Rosehill Reservoir Rehabilitation

A New Design for David A Balfour Park

Public Consultation Summary

June 2020

Left: Upper Perimeter Pathway and Service Road. Right: Lower Perimeter Pathway (red) and light poles (blue)

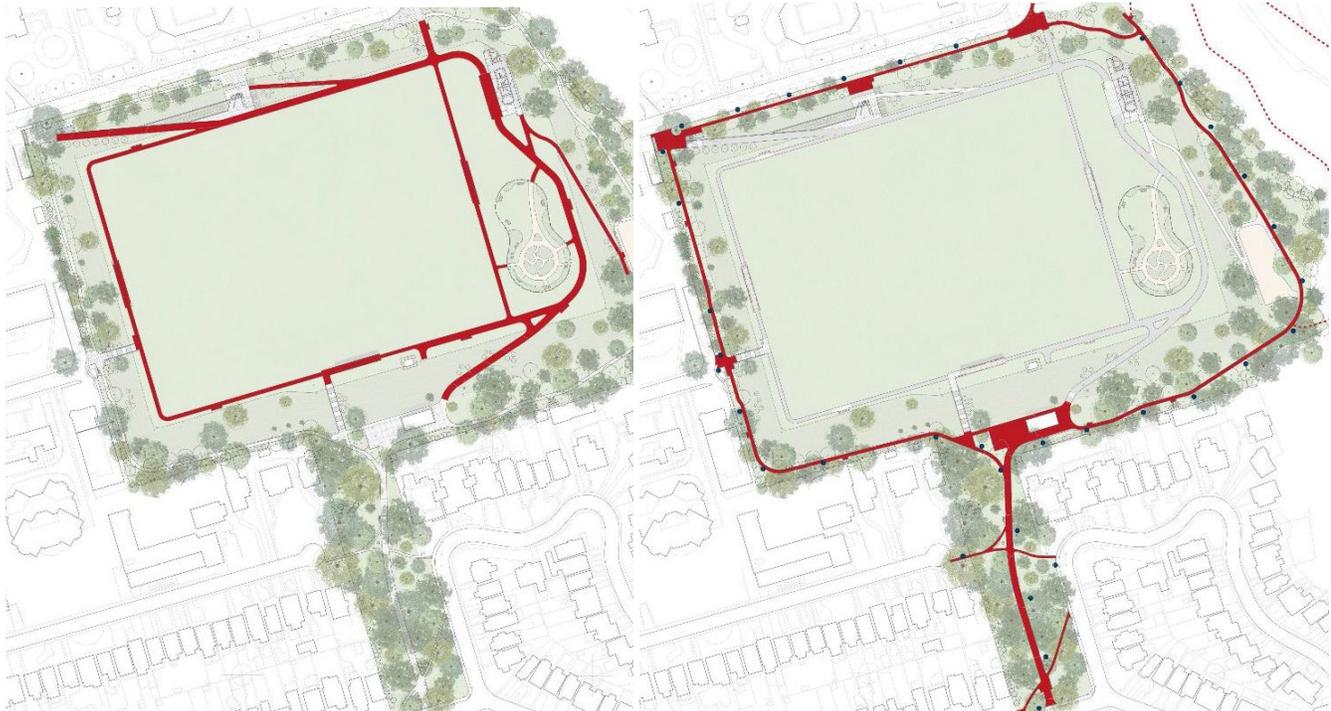
1. I like the paths on the plateau are available
2. No alternating treatments – all should be in concrete
3. Better separation of benches from the upper track, so they are not in the way of runners (All pathways with benches)
4. Add signage that this is a "pedestrian priority"

1. This path will become a skating rink in the winter

1. Better define the varying landscape experiences, canopies, ground cover
2. Path to be continuous and unbroken passing through Valve House
3. Emphasis on tree canopy is inappropriate – only need a few trees, otherwise it will not be safe
4. Widen the path as it is difficult to navigate between baby strollers, walkers, pets

The Lower Perimeter Path will be replaced in approximately the same location and will be 2.1 metres wide. Some parts of this path will be narrowed to 1.8 metres wide to avoid tree removals.

The eastern side of the Upper Perimeter Pathway width will be increased to 3.0 metres. The service road along the east side of the park is 3.5 metres wide and is pathway for both cyclists and pedestrians. Together, the widths of these paths are 6.5 metres, which meet and exceed the City's Multi-Use Trail guidelines.
